HISTORIC AND DESIGN REVIEW COMMISSION

HDRC CASE NO: 2017-334
ADDRESS: 621 CENTER ST
LEGAL DESCRIPTION: NCB 584 BLK E1/2 7 LOT 12
ZONING: RM-4, H
CITY COUNCIL DIST.: 2
DISTRICT: Dignowity Hill Historic District
APPLICANT: Felix Ziga/Ziga Architecture Studio
OWNER: Henneke Financial Group
TYPE OF WORK: New Construction
REQUEST:

The applicant is requesting conceptual approval for approval to construct a two story, single family residential structure and a rear carport.

PROPOSED SITE/ROOF
PLAN

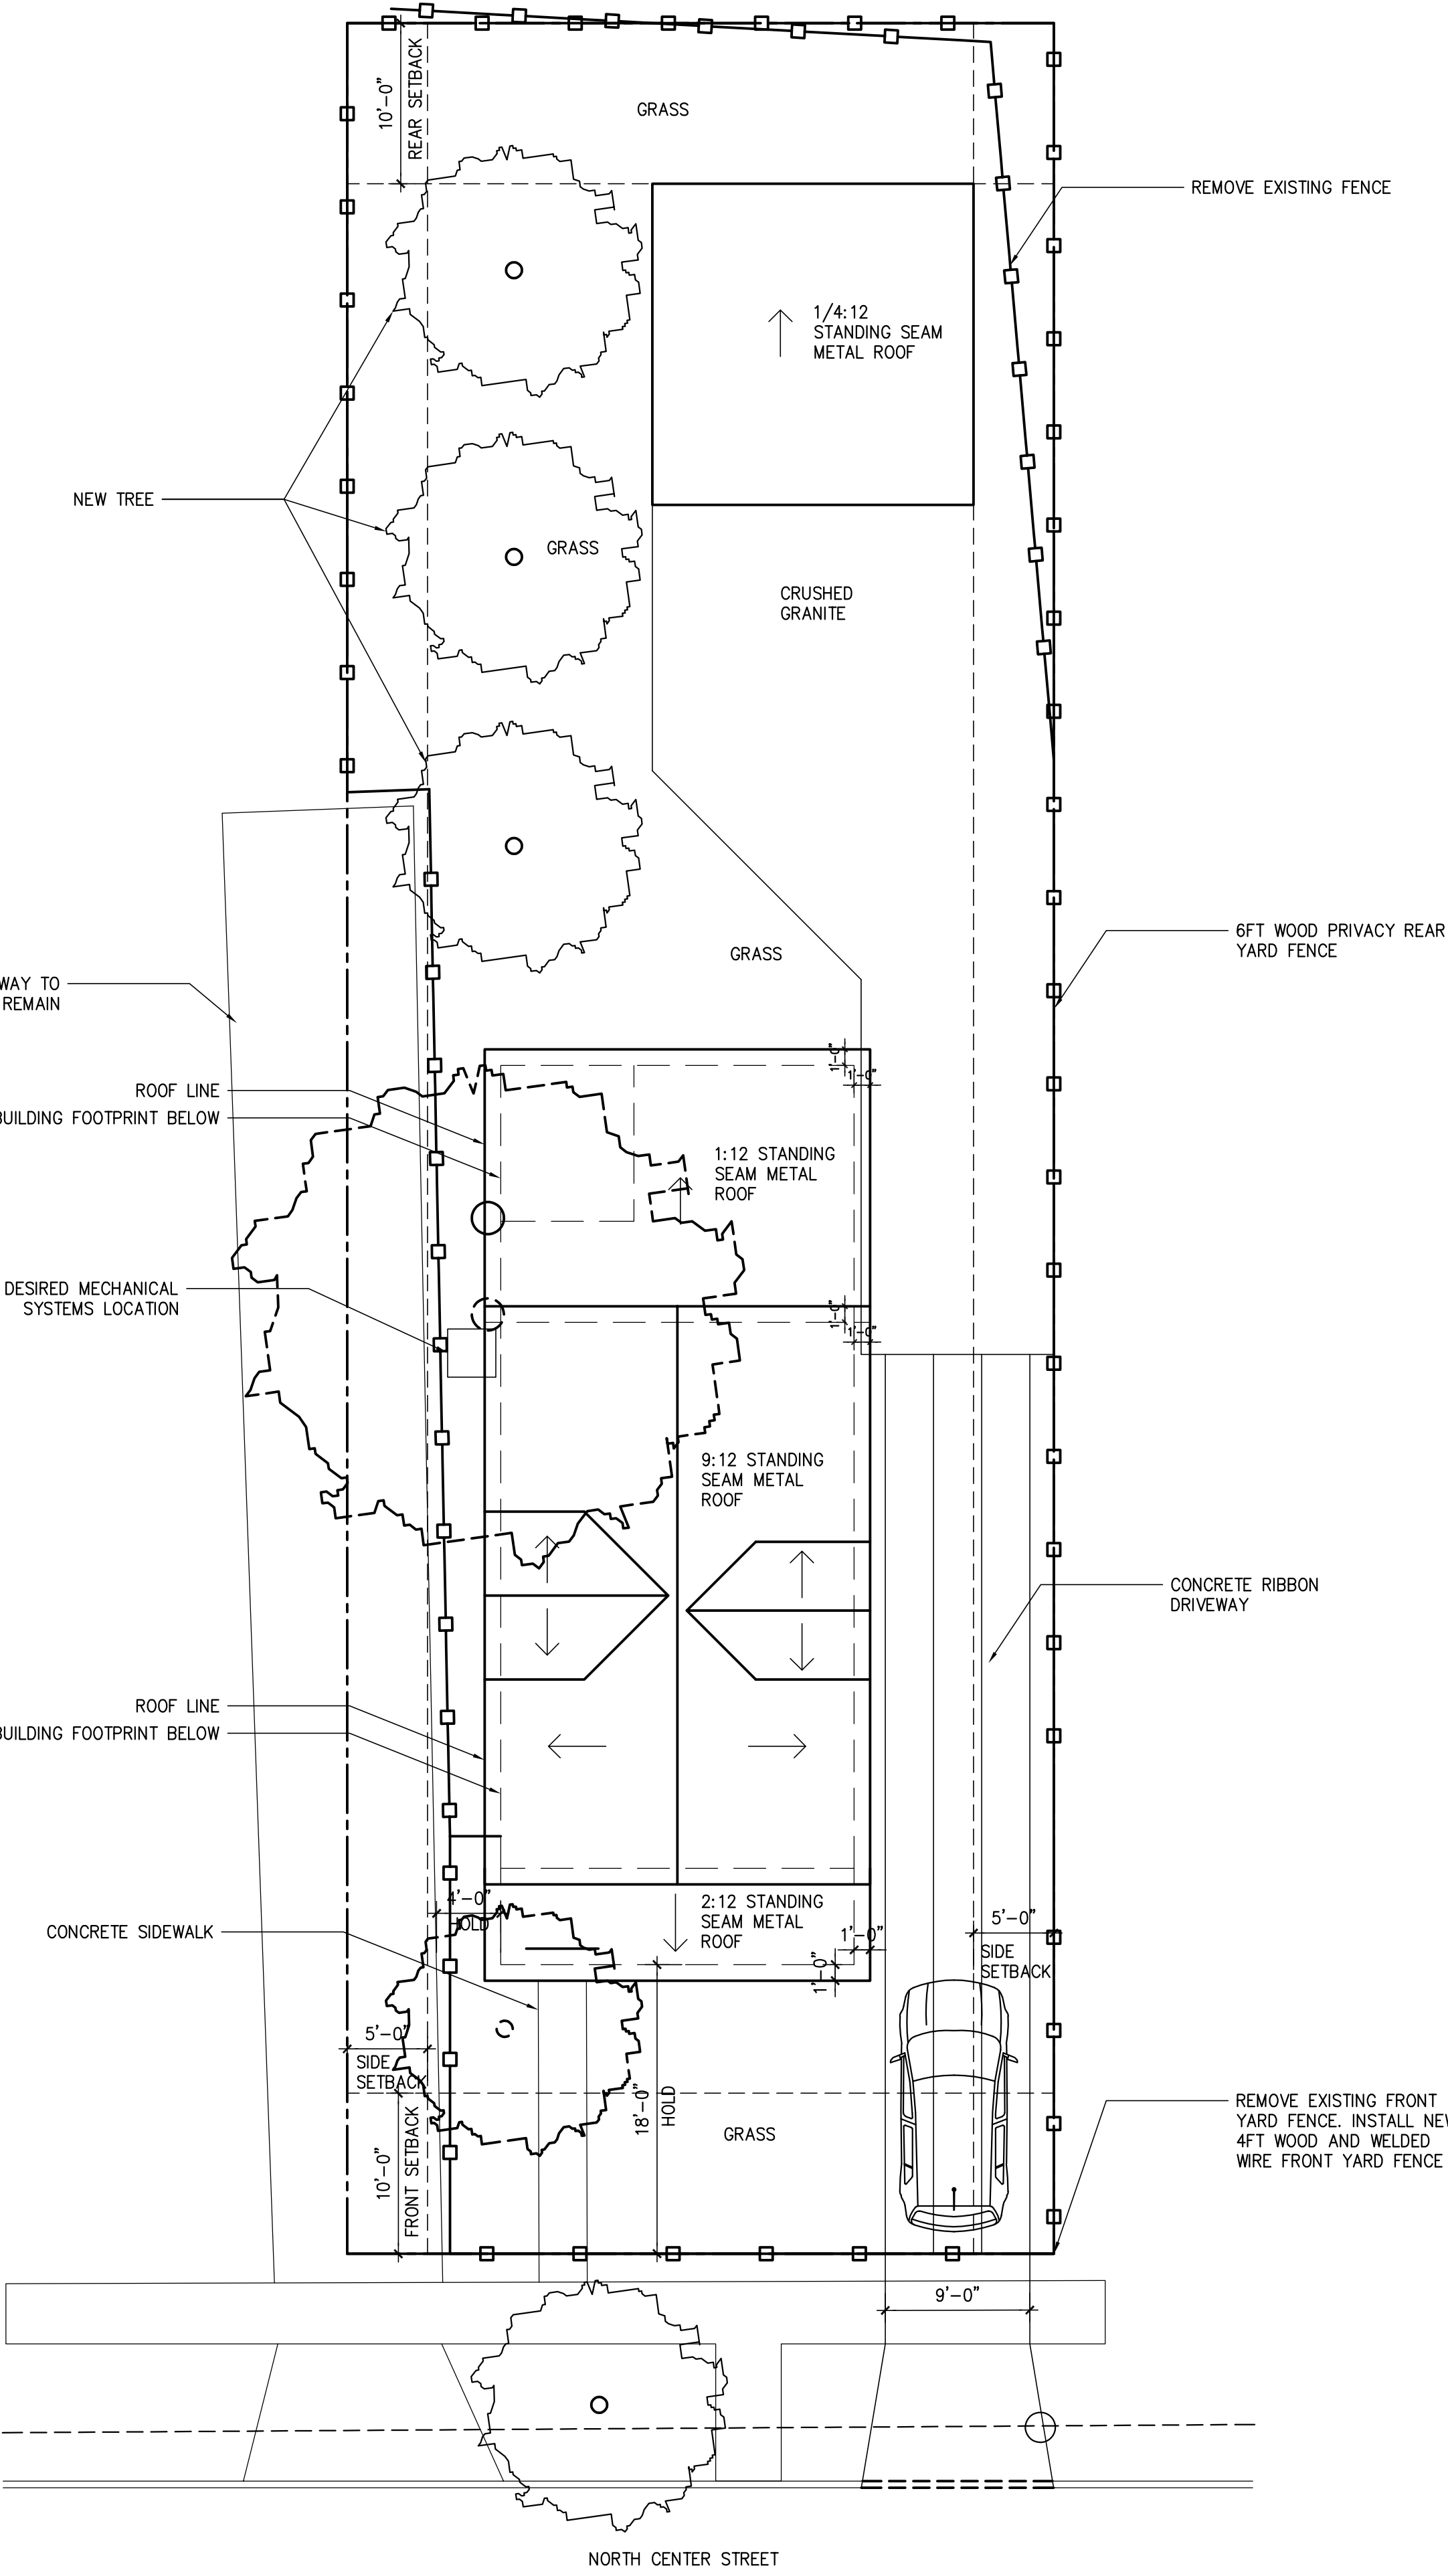
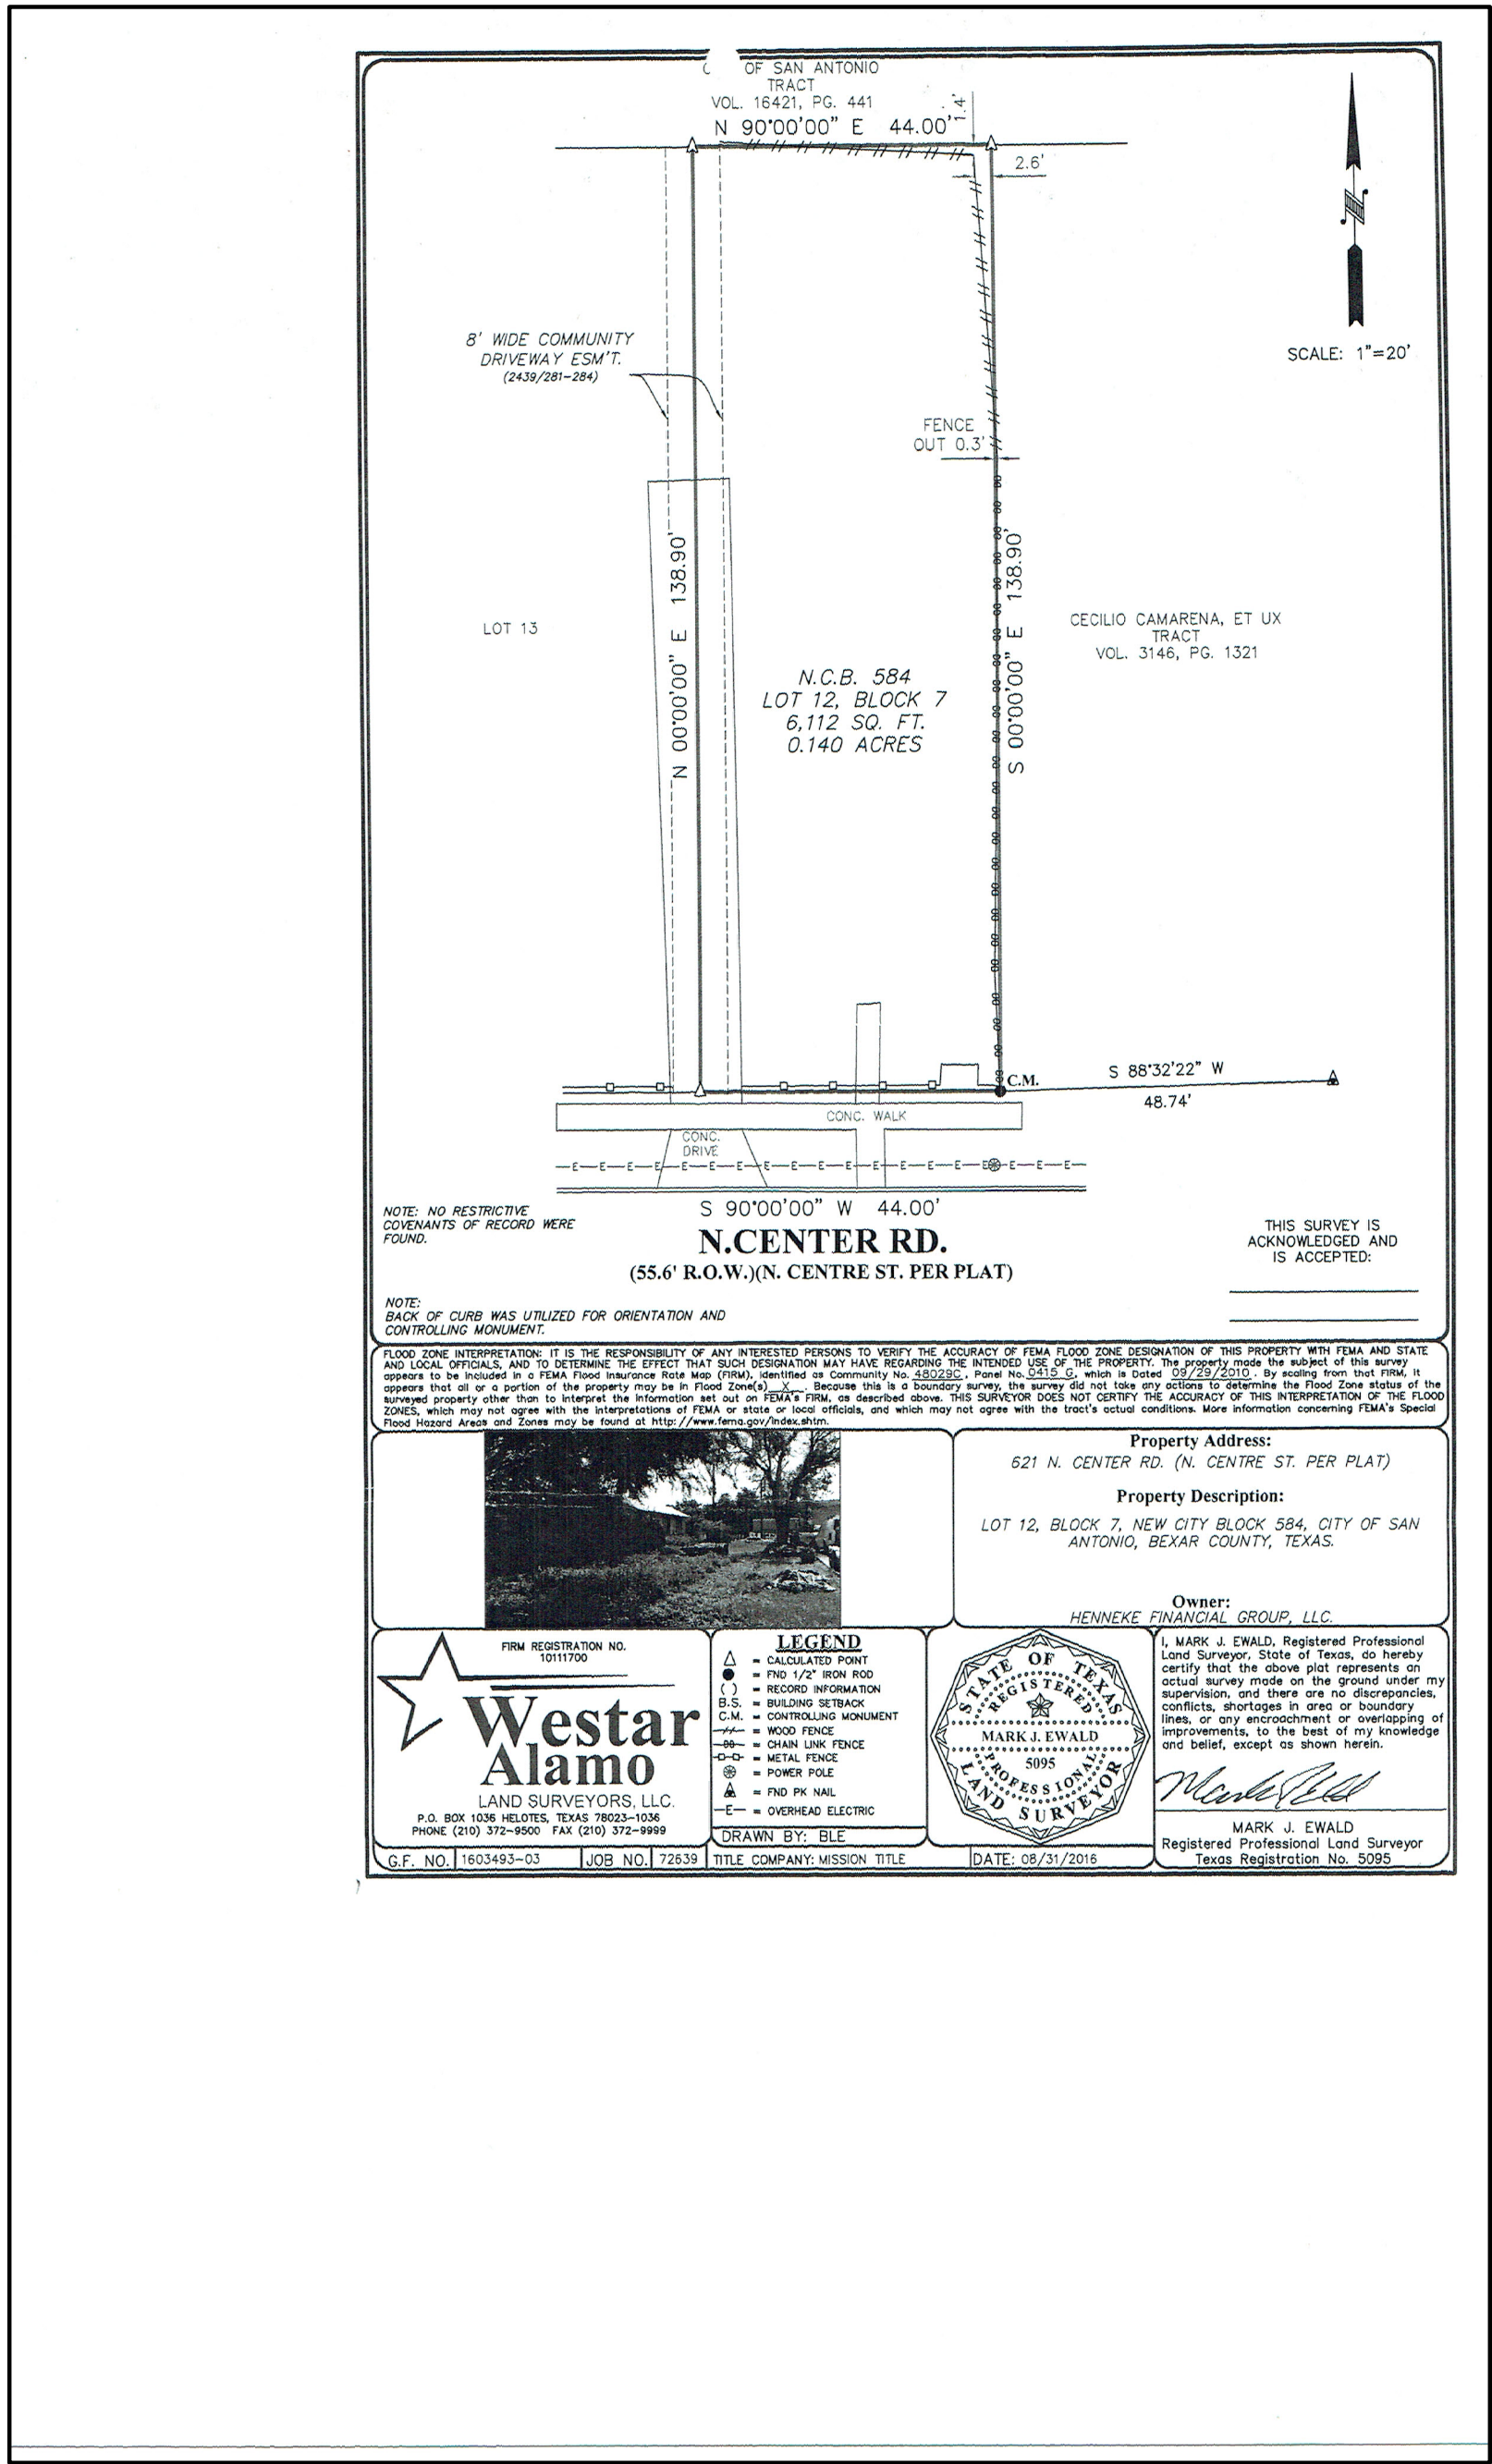
- vii. That the applicant propose a greater setback to match that of the historic structure to the west. *The applicant has noted that the proposed new construction will feature a setback that matches that of the historic structure to the west.*

- d. SETBACKS & ORIENTATION – According to the Guidelines for New Construction, the front facades of new buildings are to align with front facades of adjacent buildings where a consistent setback has been established along the street frontage. Additionally, the orientation of new construction should be consistent with the historic examples found on the block. The applicant has proposed a setback of eighteen (18) feet and has noted that the proposed new construction will feature a setback that matches that of the historic structure to the west. Staff finds that the applicant should provide a site plan noting the proposed new construction and adjacent historic structures to verify the setback.

- p. **DRIVEWAY** – The applicant has proposed to install a concrete, ribbon strip driveway on the east side of the lot. The proposed location is consistent with the examples found on this block of Center Street. The applicant should ensure that the proposed curb cut and apron are consistent with the historic profiles found on this block. The applicant has noted an overall width of nine (9) feet.

- t. **FENCING** – Front yard fences are found along this block of Center. The applicant has noted the installation of a cattle panel fence in the front yard and a rear yard privacy fence.. Staff finds the installation of this fence appropriate; however, the height is not to exceed four (4) feet in height in the front yard and six (6) feet in height in the side and rear yard.

- ii. That the proposed front yard fencing does not exceed four (4) feet in height and that the rear privacy fencing does not exceed six (6) feet in height.

- iv. That the applicant provide staff with a site plan noting the proposed new construction’s setback from the street in context with the setbacks of the adjacent structures.
